A. Amendments to the Drawings

Figures 4, 5, 6, 9, 13, 21, 27 and 29 have been amended to address the errors found by the Examiner. More specifically,

FIG. 4

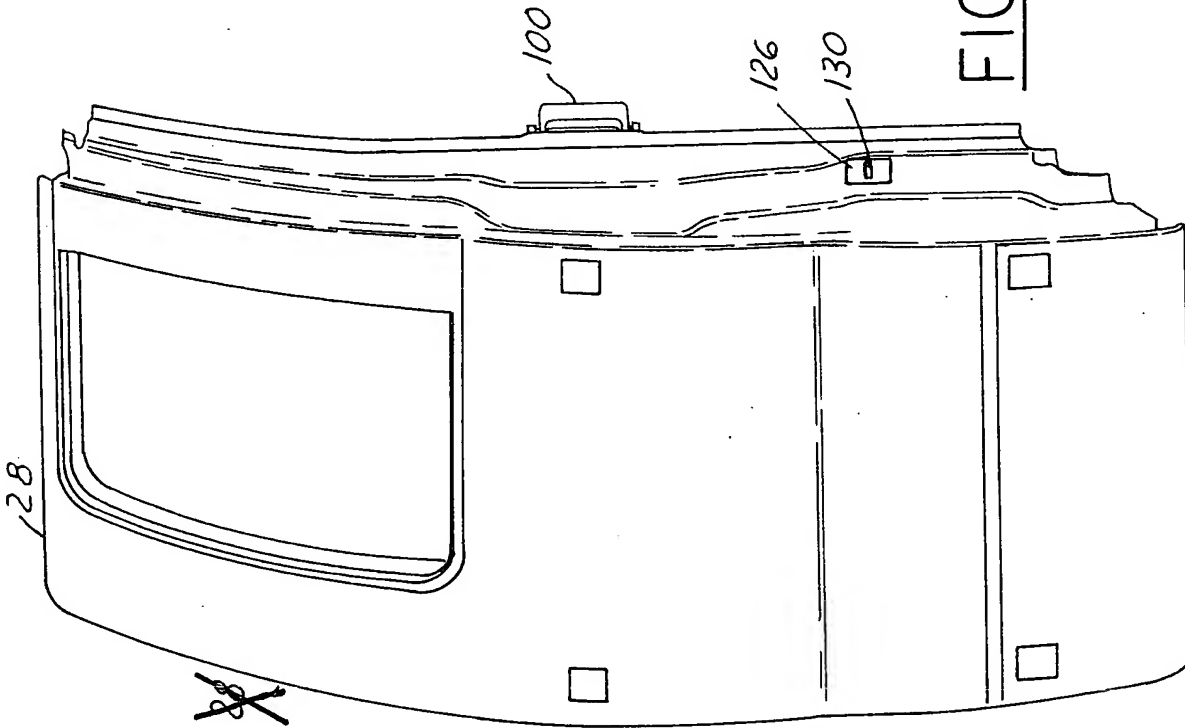
Figure 4: The lowermost "28" has been deleted.

FIG. 5

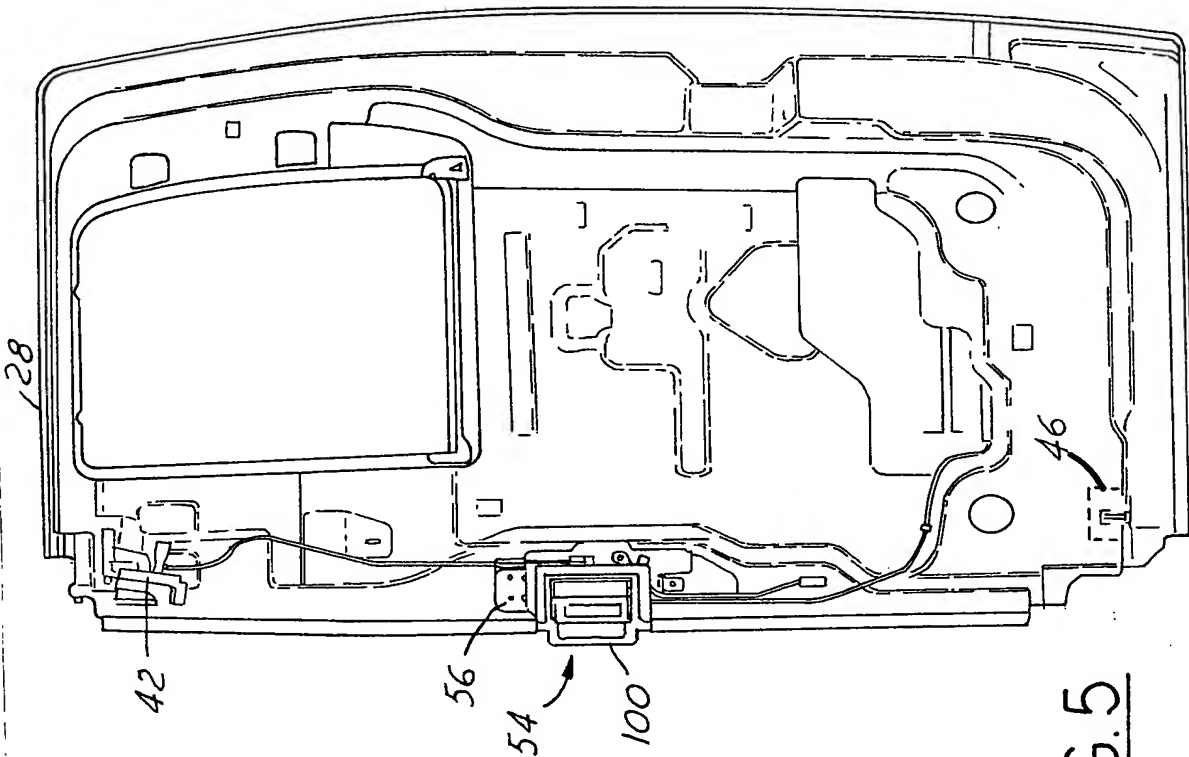
Figure 5: A lead line has been added to "46".

FIG. 6

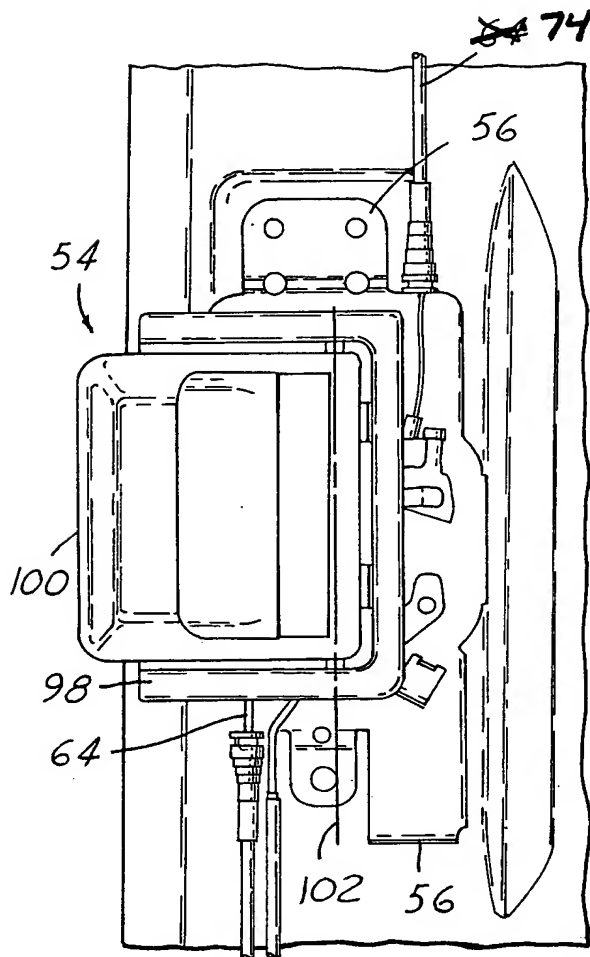
Figure 6: Reference number "64" has been changed to "74".

FIG. 7

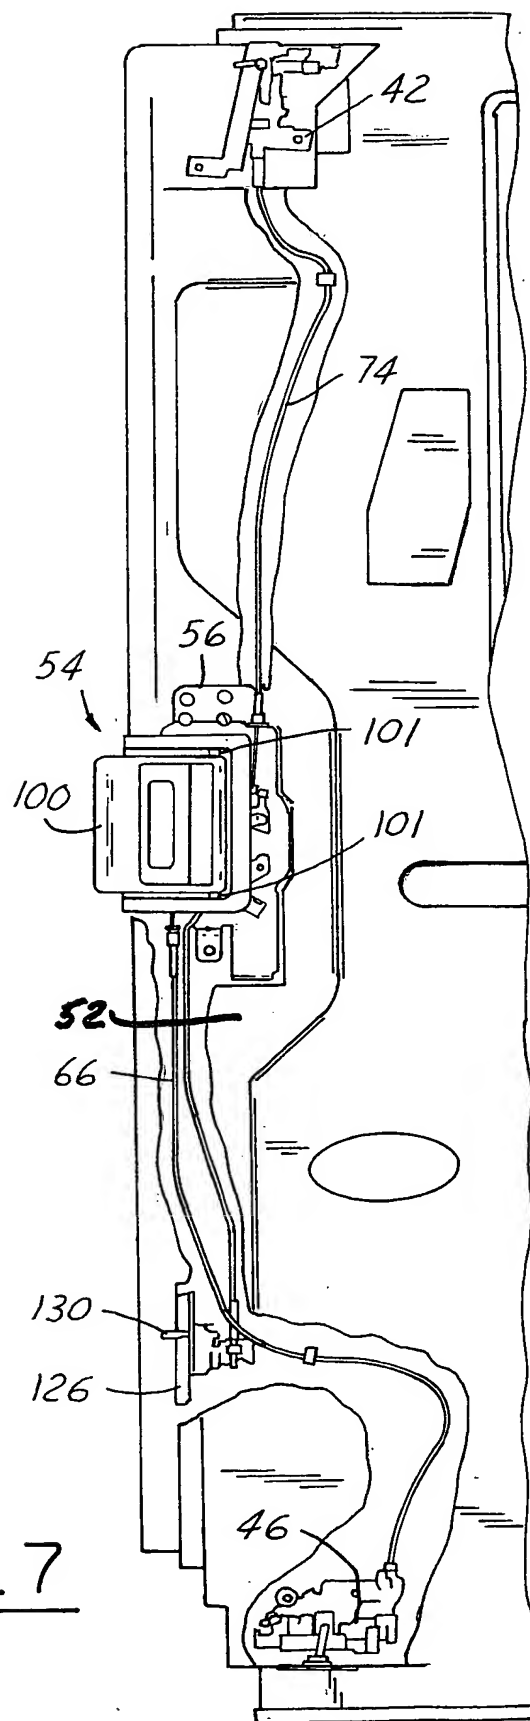
Figure 7: Reference number "52" has been added.

FIG. 9

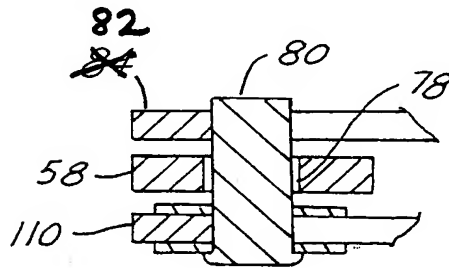
Figure 9: Reference number "84" has been changed to "82".

FIG. 13

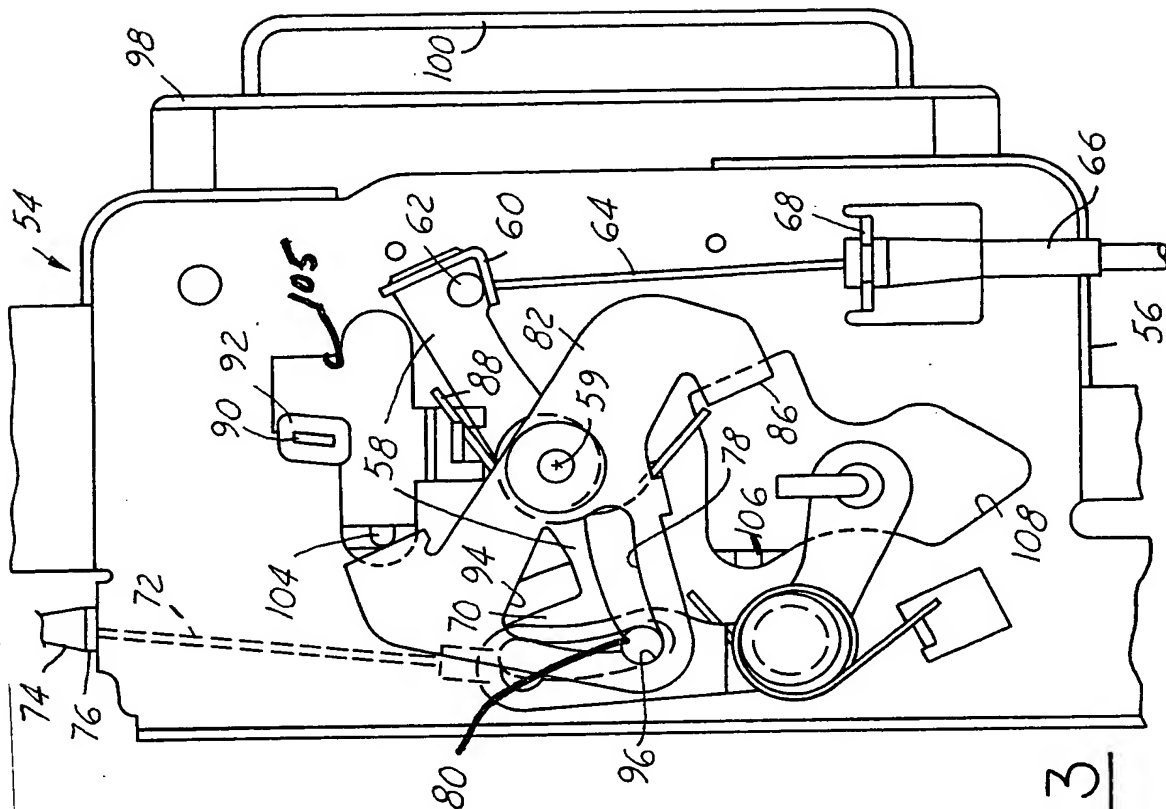
Figure 13: The lead line for reference number "80" has been extended. A lead line has been added for "106". Reference item "105" has been added.

FIG. 21

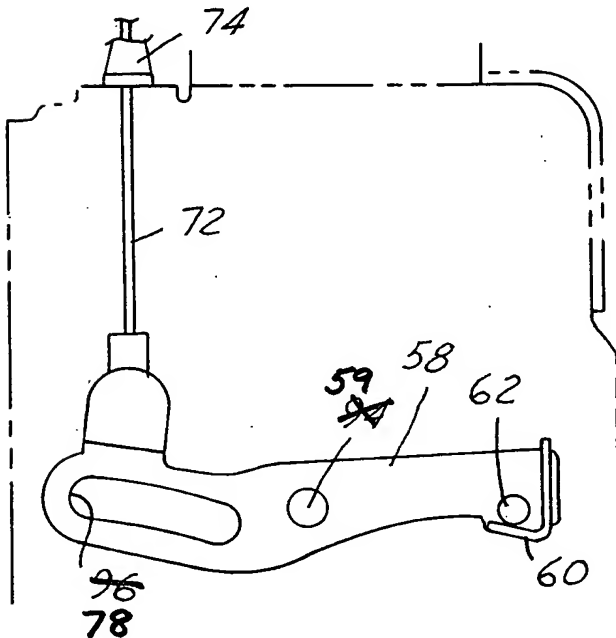
Figure 21: Reference number "94" has been changed to "59" and reference number "96" has been changed to "78".

FIG. 27

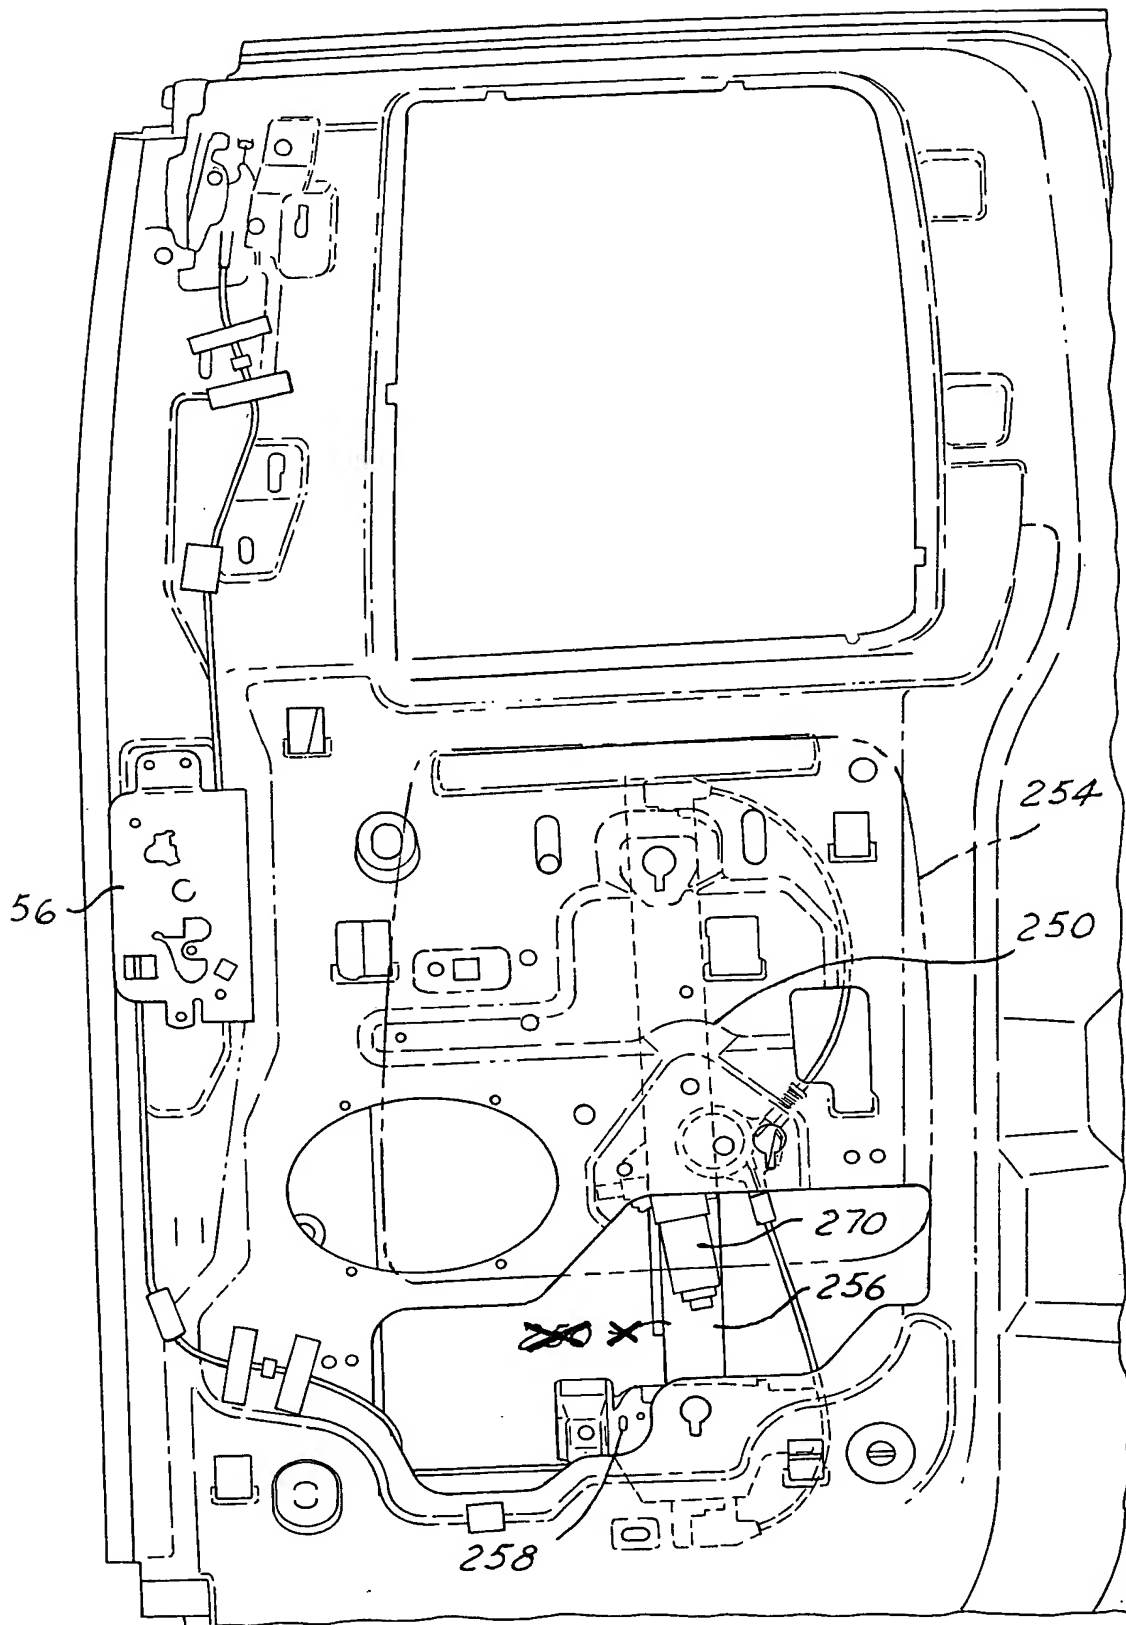
Figure 27: The lowermost reference number "250" and its lead line have been deleted.

Figure 27: Reference number "270" has been changed to "271".
